HELIOS RENEWABLE ENERGY PROJECT

FLOOD RISK ASSESSMENT

Helios Renewable Energy Project Revised Scoping Document

JBA Project Code 2022s0454
Contract
Client
Day, Date and Time
Author Kevin Haseldine
Subject Helios Solar Farm FRA methodology review

Figure 1: Existing Model Coverage

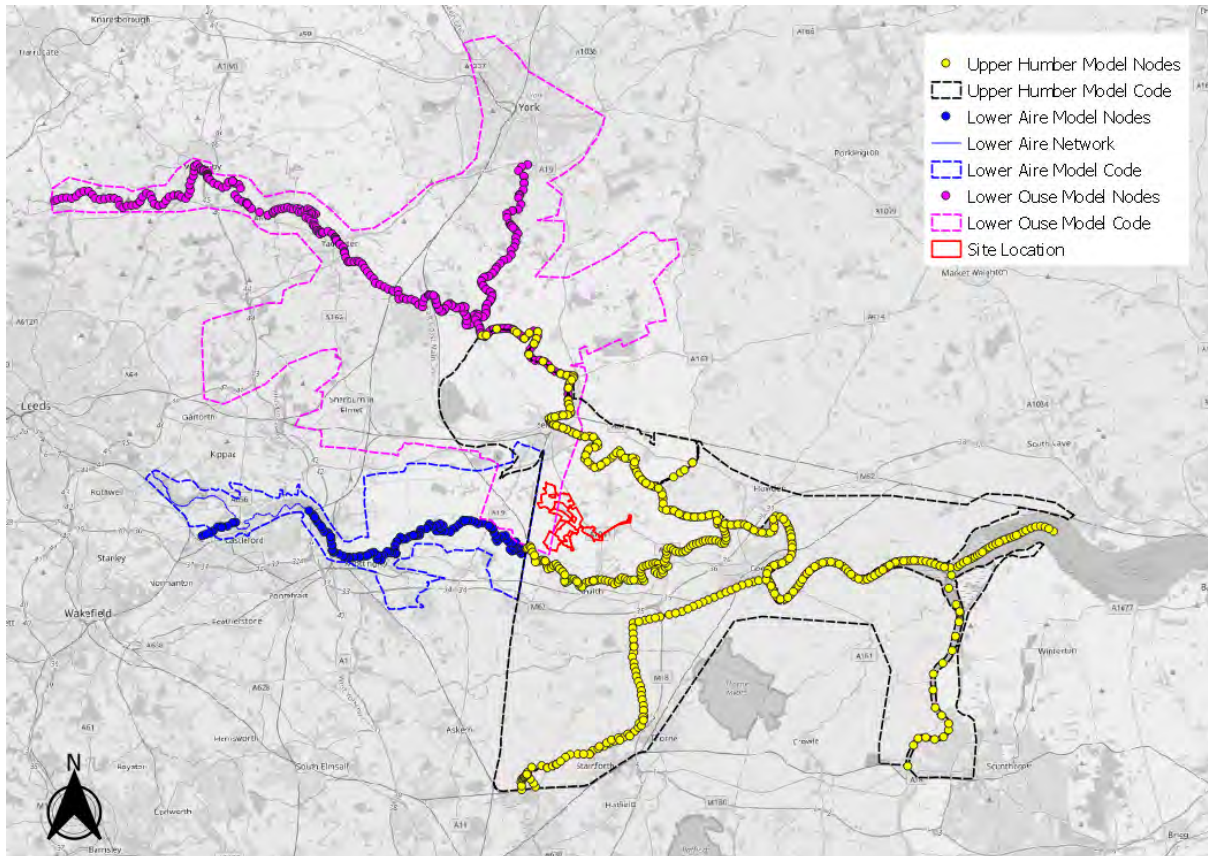
It is proposed to use the Upper Humber (2016) model as the primary model and extend the Ouse and Aire watercourses upstream as necessary using geometry from the Lower Aire and Lower Ouse models. Superfluous downstream tributaries not thought to influence flood risk at the site will be removed to reduce model simulation times.

The Humber 2100+ Extreme Water Levels model will be utilised to inform boundary conditions with the model in line with the EA suggestions.

Figure 2: Datasets used to define the water level profile on the Humber estuary and its tidal tributaries

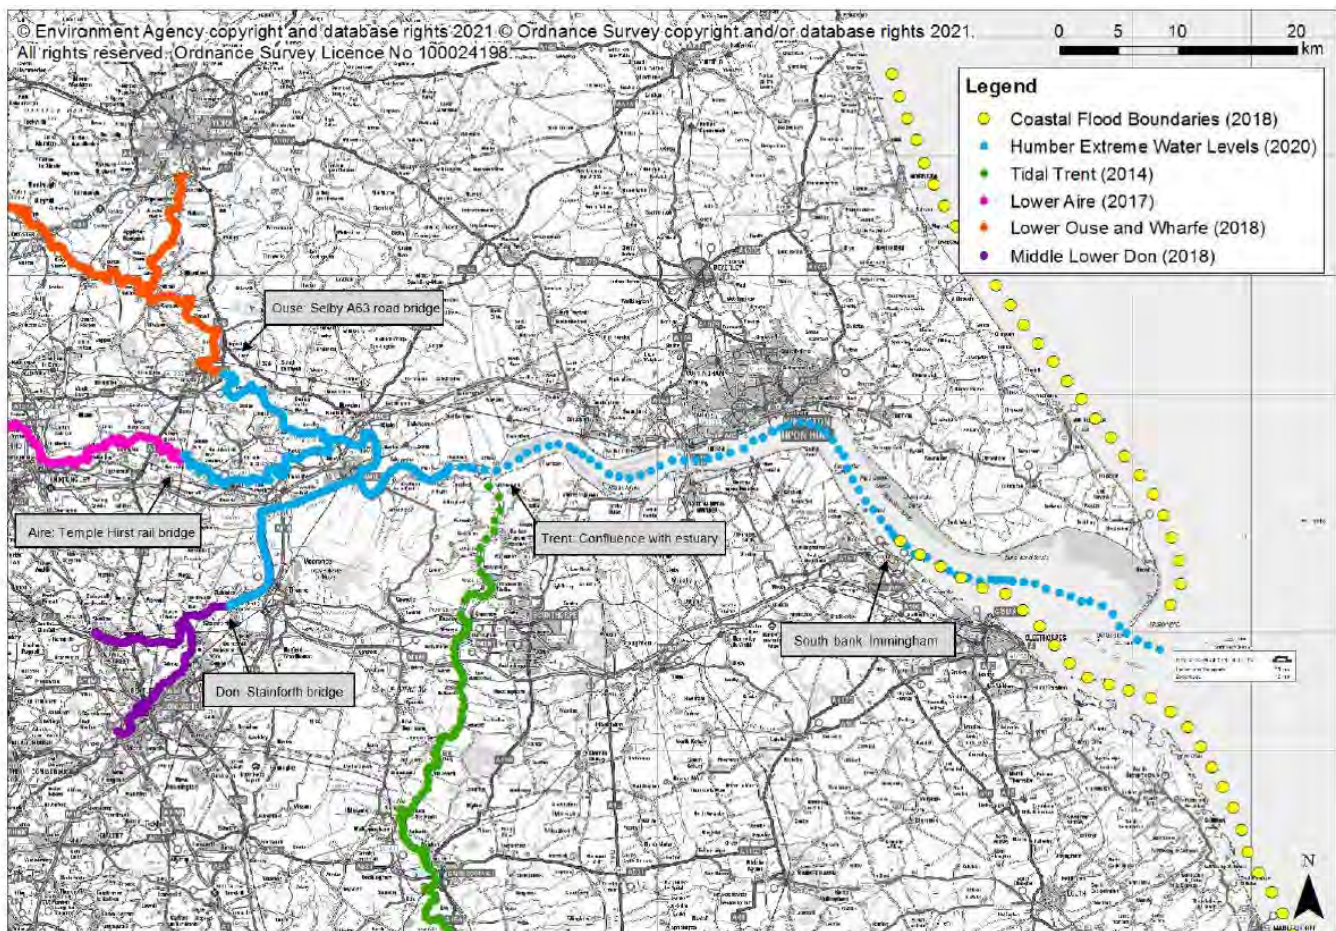
The FRA project should make use of the HEWL project. Whilst the Upper Humber and Lower Aire model are likely to include more detail in terms of local topography compared to the HEWL 1D only model, the HEWL supersedes the boundary conditions of these older models. It is recommended that Aegaea revisit the modelling methodology with the HEWL included. The update should consider the relevant merits of each of the three models / projects and identify how each can be used to offer the best representation of flood risk at the site.
